<b>ITEM: 6.4</b>	<b>COMMITTEE OF ADJUSTMENT REPORT SUMMARY MINOR VARIANCE APPLICATION FILE NUMBER A059/23 464 WESTRIDGE DRIVE, KLEINBURG</b>
------------------	---

**COMMITTEE OF ADJUSTMENT REPORT  
MINOR VARIANCE APPLICATION  
A059/23  
464 WESTRIDGE DRIVE, KLEINBURG**

<b>ITEM NUMBER: 6.4</b>	<b>CITY WARD #: 1</b>
<b>APPLICANT:</b>	Sylvain & Sharon Nadeau
<b>AGENT:</b>	Lucas Cocomello
<b>PROPERTY:</b>	464 Westridge Drive, Kleinburg
<b>ZONING DESIGNATION:</b>	See below.
<b>VAUGHAN OFFICIAL PLAN (2010) DESIGNATION:</b>	Vaughan Official Plan 2010 ('VOP 2010'): "Low-Rise Residential"
<b>RELATED DEVELOPMENT APPLICATIONS:</b>	None
<b>PURPOSE OF APPLICATION:</b>	Relief from the Zoning By-law is being requested to permit a proposed cabana.

SITE PLAN,  
SITE STATISTICS

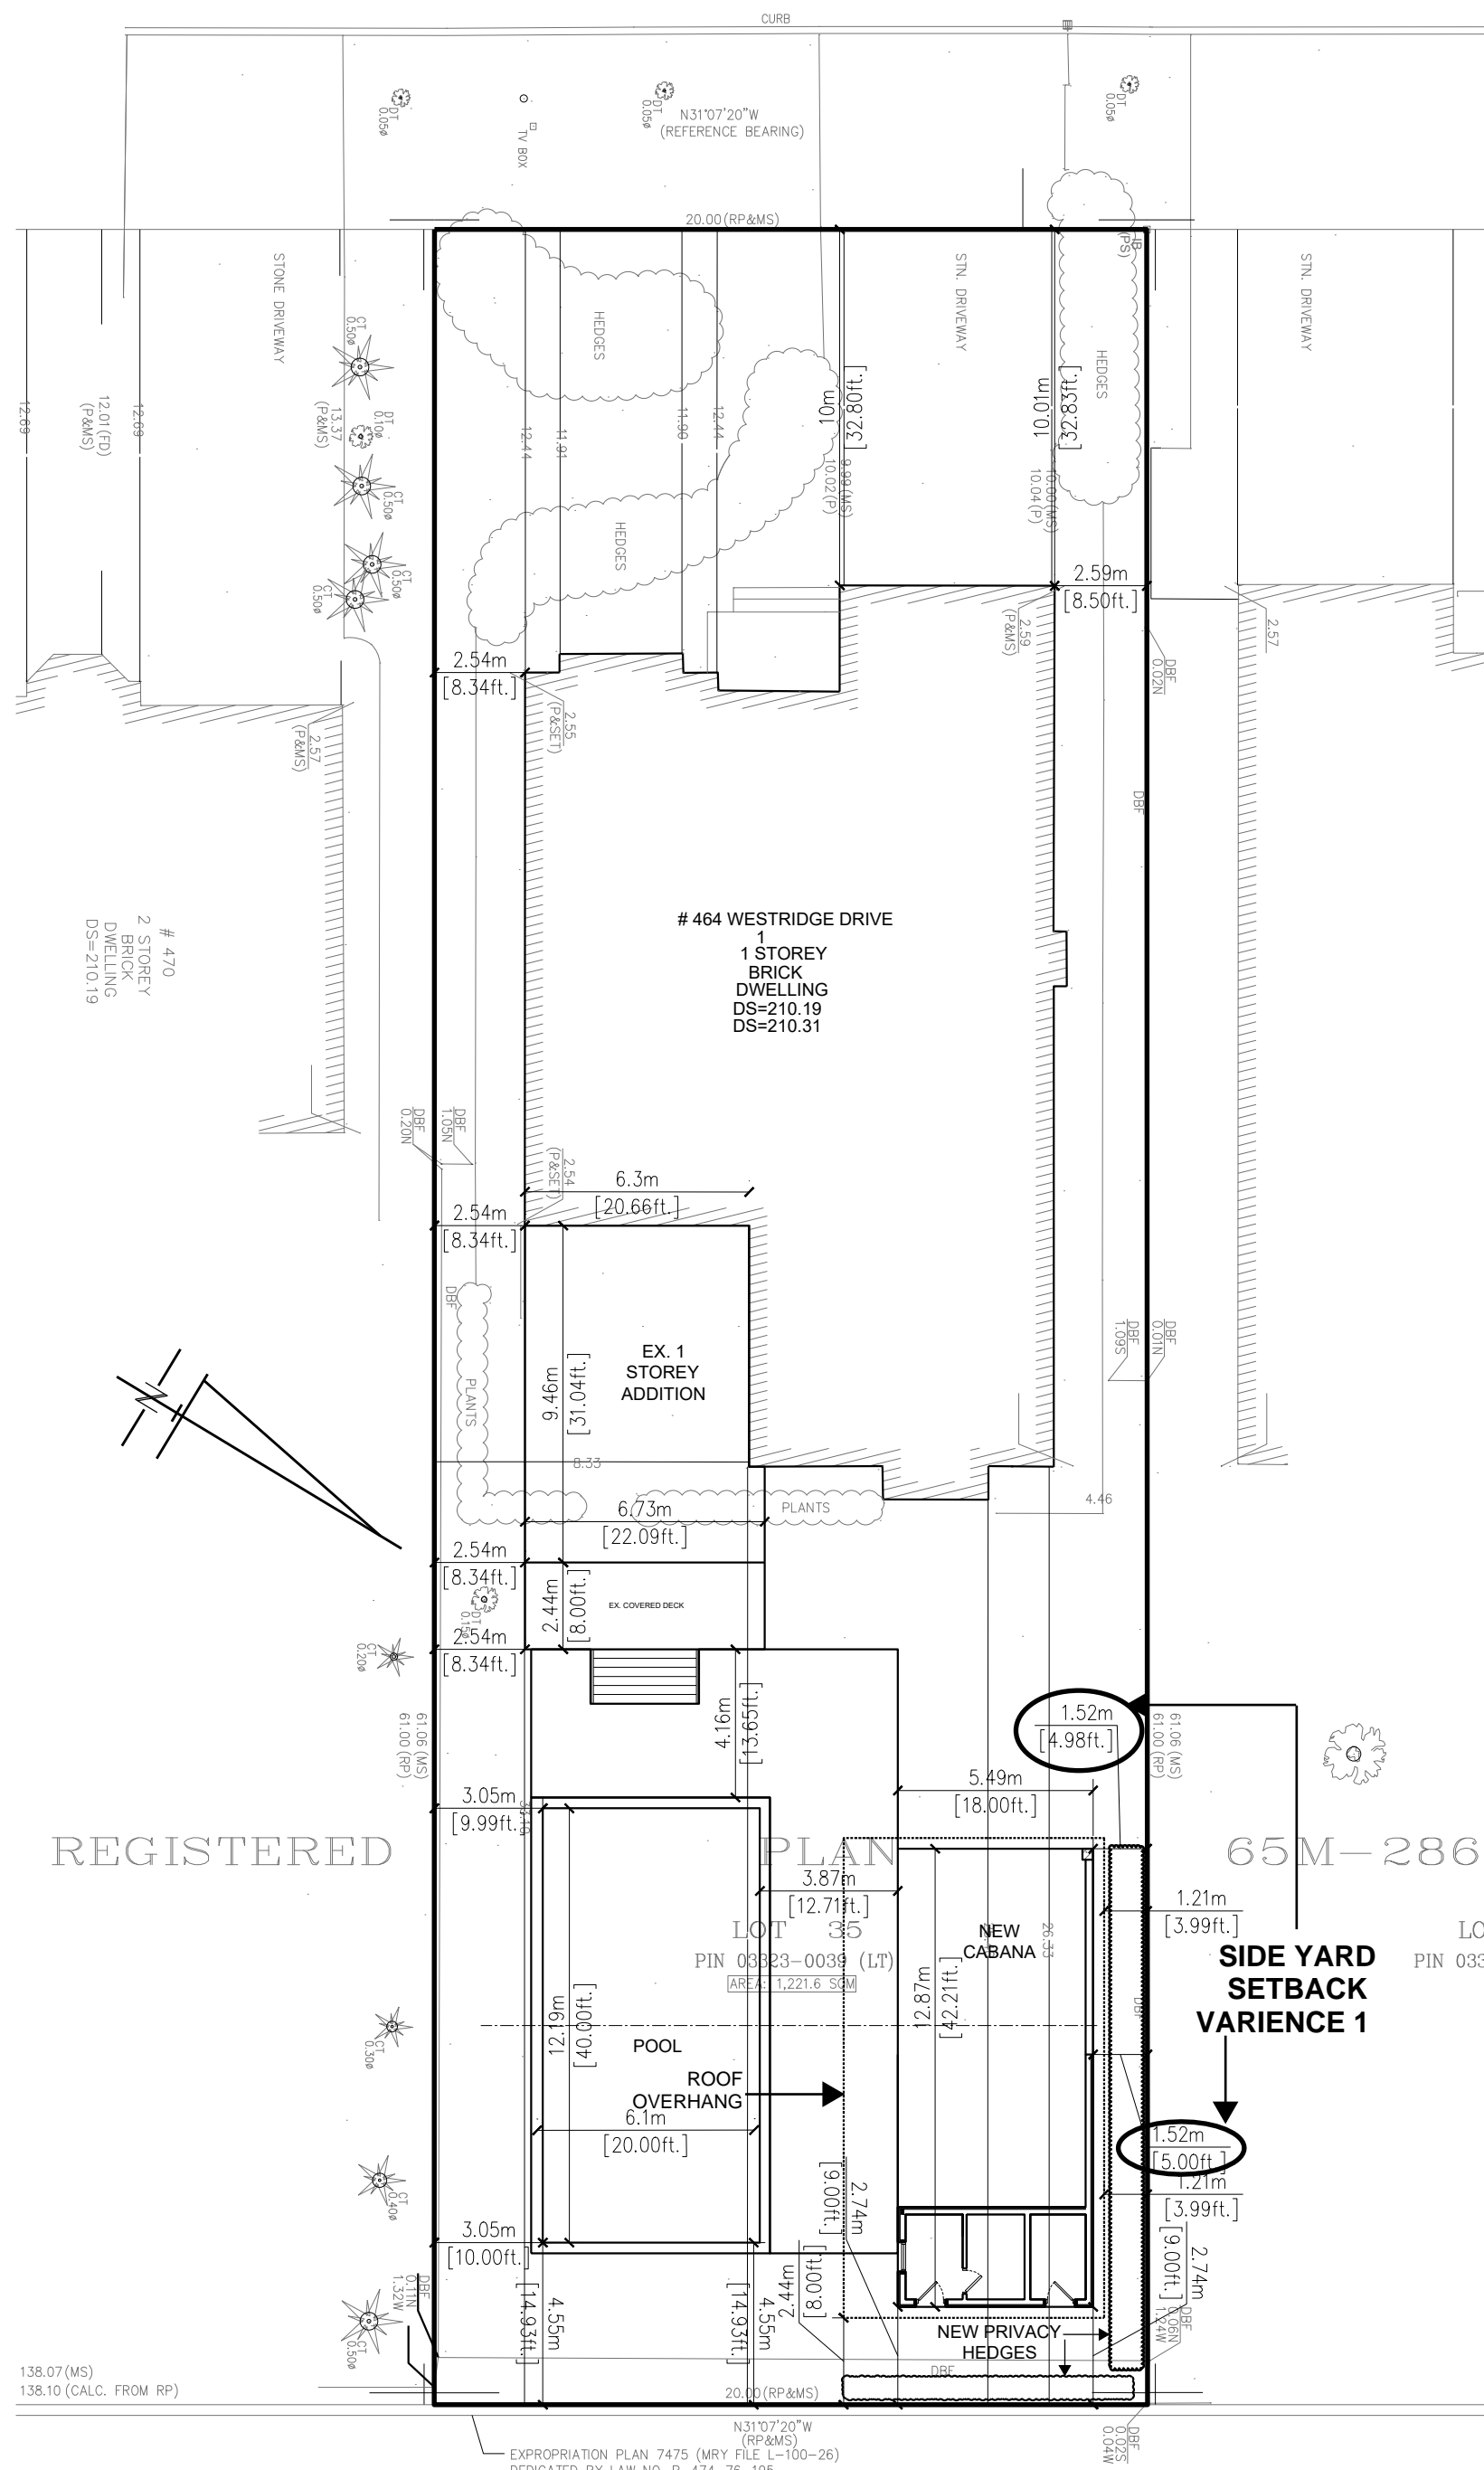
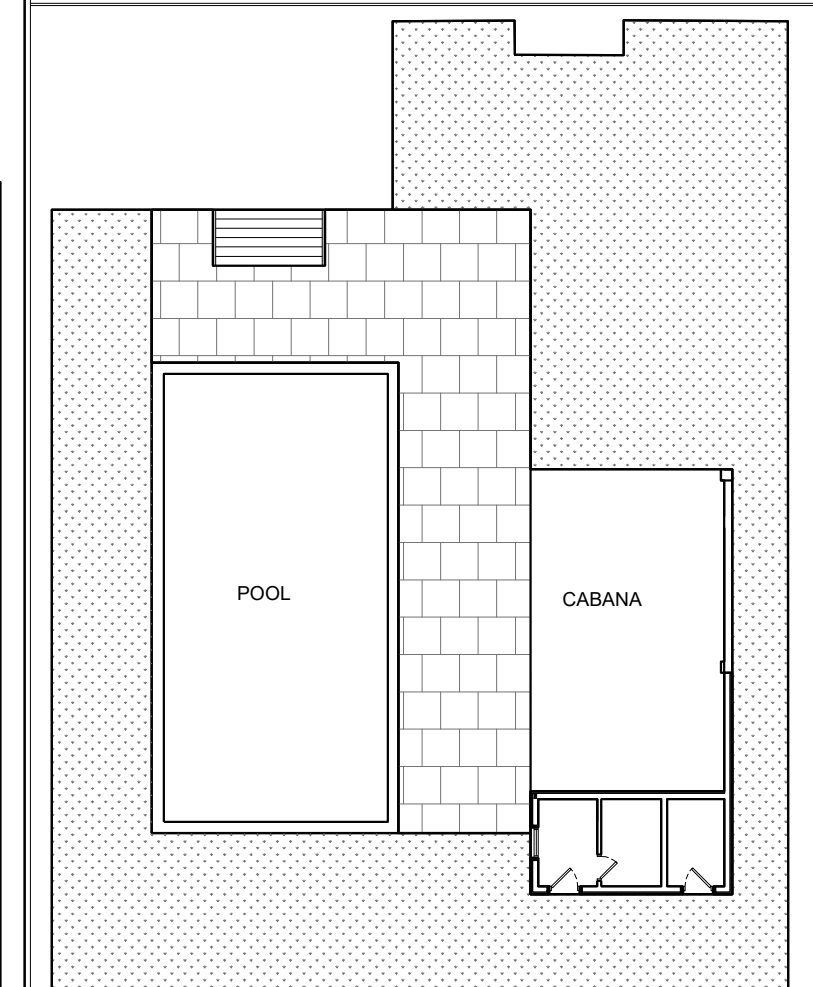
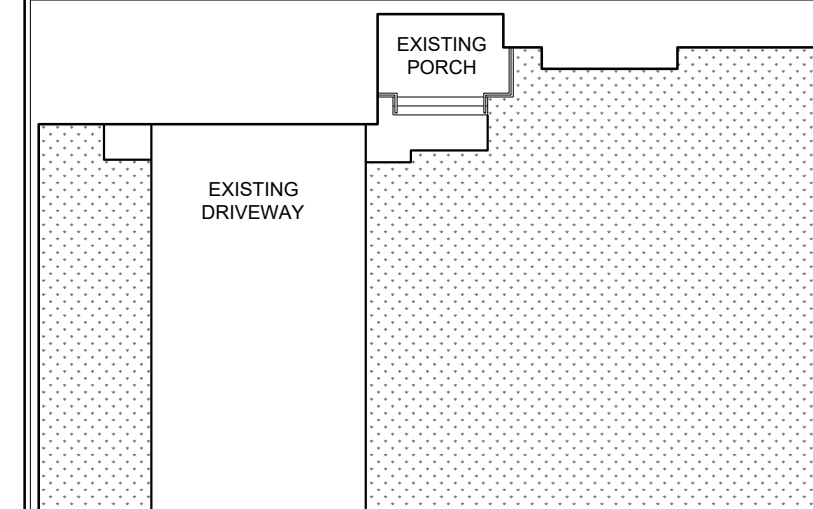
<b>**See Schedule B for Development Planning Comments.</b>	
<b>Development Planning Recommended Conditions of Approval:</b>	That the final Landscape Plan, indicating the location of hedge plantings along the north and east sides of the cabana, be approved to the satisfaction of the Development Planning Department

The Development Planning Department has no objection to Variances 1 and 3 for the interior side yard setback and height of the cabana. The cabana has a slanted roof that is lowest along the northern side, facing the neighbouring property. The roof extends to the south, creating an overhang facing the pool. The proposed 3.82 m cabana height is measured from the highest roof edge facing the pool to established grade. The height of the cabana when measured from the roof section closest the north interior side lot line to established grade is approximately 3.37 m. Hedge plantings are proposed along the north and east sides of the cabana to provide screening to mitigate privacy and massing impacts. The slanted roof design of the cabana, in conjunction with the proposed plantings, is not anticipated to pose adverse impacts to the neighbouring property to the north. The reduction to the interior side yard setback will also maintain an appropriate area for maintenance access. As such, the cabana is not anticipated to pose adverse use, privacy, or massing impacts to the neighbouring properties.

Upon recommendations from the Development Planning Department, the Owners have revised their application to reduce the size of the cabana. The Development Planning Department has no objection to Variance 2 for the revised lot coverage of the cabana. Development Planning Department staff had concerns with the size and length of the cabana as the continuous built form of the cabana created adverse massing impacts to the neighbouring properties. Reducing the size of the cabana will mitigate the adverse impacts associated with the building's built form, particularly those impacts facing the neighbour to the north. Much of the proposed additional lot coverage is also comprised of the area underneath the roof overhang. The lot coverage of the fully enclosed structure is approximately 70.63 m<sup>2</sup>, which is a minor increase to the permitted 67 m<sup>2</sup>. As such, the increase in lot coverage for the cabana can be considered appropriate for the size of the lot and will not pose adverse use or massing impacts to the neighbouring properties.

**Change: addition of more hedge plantings**

1. That the final Landscape Plan, indicating the location of hedge plantings along the north and east sides of the cabana, be approved to the satisfaction of the Development Planning Department.
